# NONA PARK LOTS 5 & 6 SPMP

<p><b>Owner/Applicant</b>                  Ryan Stahl,                  Lake Nona Investors, LLC</p>          <p><b>Project Planner</b>                  Michaëlle Petion, AICP</p>	<p><b>Property Location:</b> 9402, 9434 Narcossee Rd. (North of Kensington Row Ct., south of Dowden Rd., and west of Narcossee Rd. ) (Parcel ID #06-24-31-5127-06-000, 06-24-31-5127-05-000) (±2.53 acres, District 1)</p>          <p><b>Applicant's Request:</b>                  The applicant is requesting Specific Parcel Master Plan (SPMP) approval for Nona Park outparcels 5 &amp; 6 comprised of 9,720 sq. ft. of office, 5,678 sq. ft. of eating and drinking and 3,238 sq. ft. of retail uses.</p>
<p><b>Updated:</b> November 24, 2015</p>

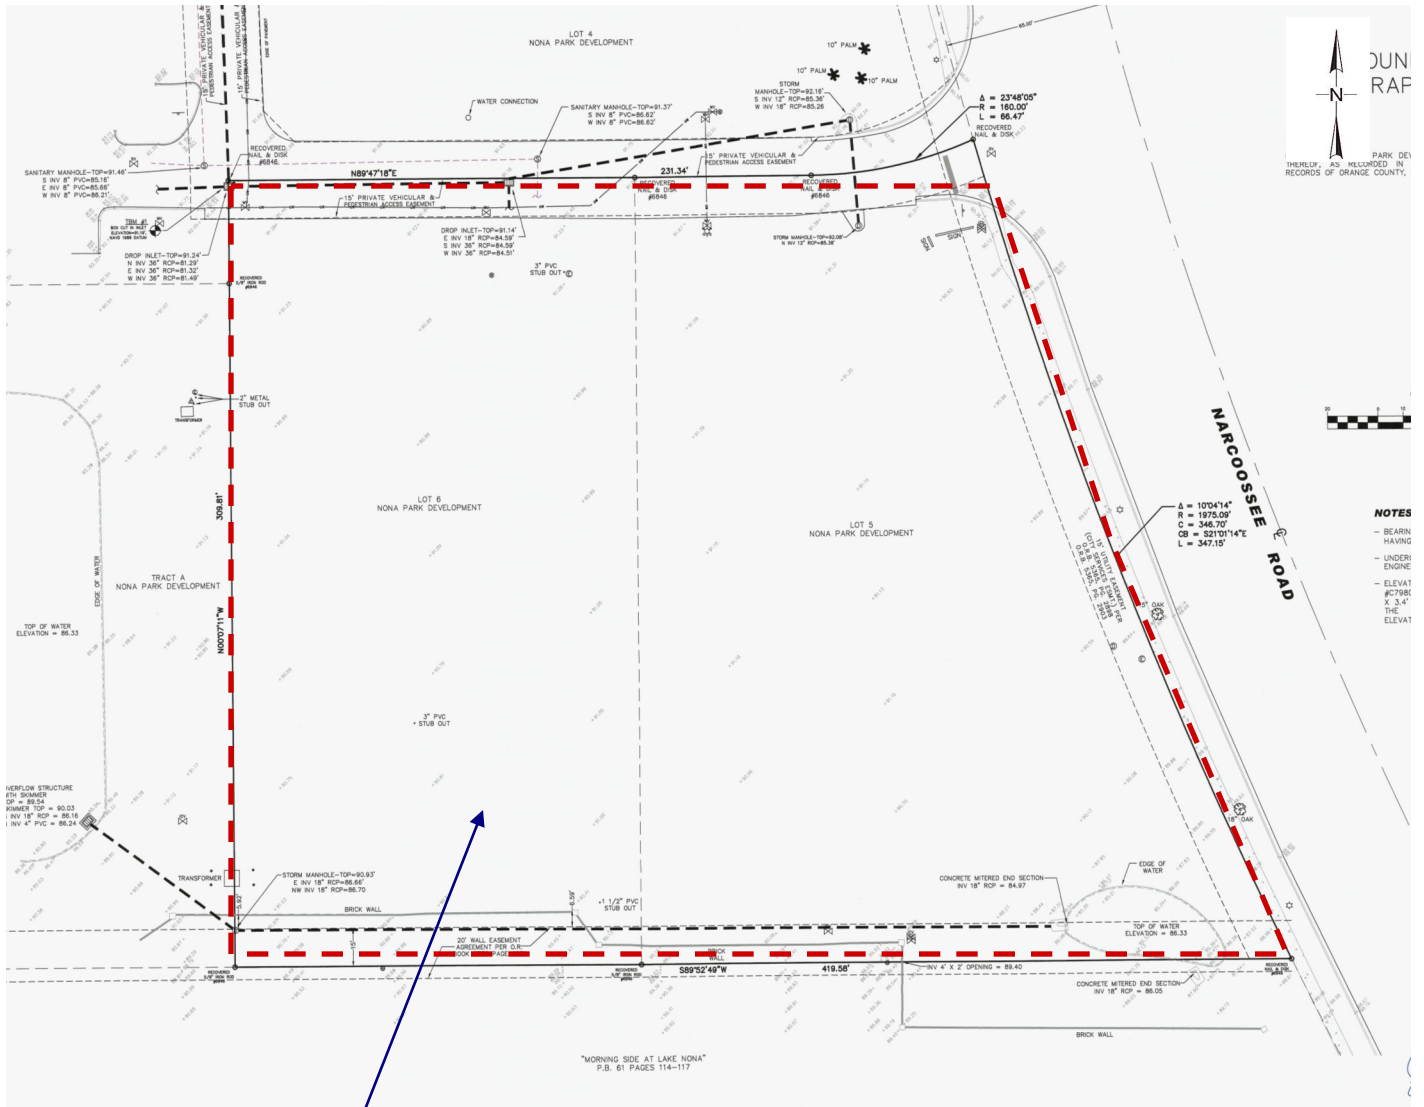
Part 3B of chapter 61 of the City Land Development Code (LDC) requires a minimum of 3 ft. perimeter landscaping between the building and the parking lot. Typically the landscaping is adjacent to the building. The applicant proposes approximately 5 ft. of landscaping and has the landscaping located adjacent to the parking stall (for Buildings A and B). As proposed, the design will allow for outdoor seating and landscaping will screen the vehicle and their lights.

As it relates to drive-throughs, the zoning standards default to the AC-2 zoning district, consistent with ASD-1 requirements. Proposed are three drive-through uses, which are permitted by-right in the AC-2 district. Development standards include a required bypass lane or minimum drive-through lane width of 16 ft. Also, restaurant uses require minimum on-site staking of 6 cars with a minimum of 5 cars for the possible dry cleaner use. The proposal is compliant.

Site access is provided along the northern property line off of the internal cross access road. Proposed are 87 parking spaces, which is in compliance with the required minimum and maximums (See Table 2 for details).

1. The bypass lane shall be at least 16 feet wide.
2. Pedestrian connections in the form of sidewalks shall be provided on the north side of lots 5/6 A and 5/6 C from Narcoossee Road. Provide pedestrian access to connect each lot internally. Currently there is no connection from BLDG A to BLDG B or BLDG C. All pedestrian connections and sidewalks shall be ADA compliant including but not limited to handicapped accessible ramps and 12 inch wide thermoplastic lines that are parallel to crosswalks.

3. Sidewalks perpendicular to parking spaces shall be a minimum of 6 feet wide unless speed humps are utilized.
4. At all project entrances, clear sight distances for drivers and pedestrians shall not be blocked by signs, buildings, building columns, landscaping, or other visual impediments. No structure, fence, wall, or other visual impediment shall obstruct vision between 3 feet and 8 feet in height above street level. The street corner/ driveway visibility area shall be shown and noted on construction plans and any future site plan and landscape plan submittals. The applicant shall design the site plan as necessary to comply with the Florida Greenbook and the FDOT Design Standards Index most current editions.
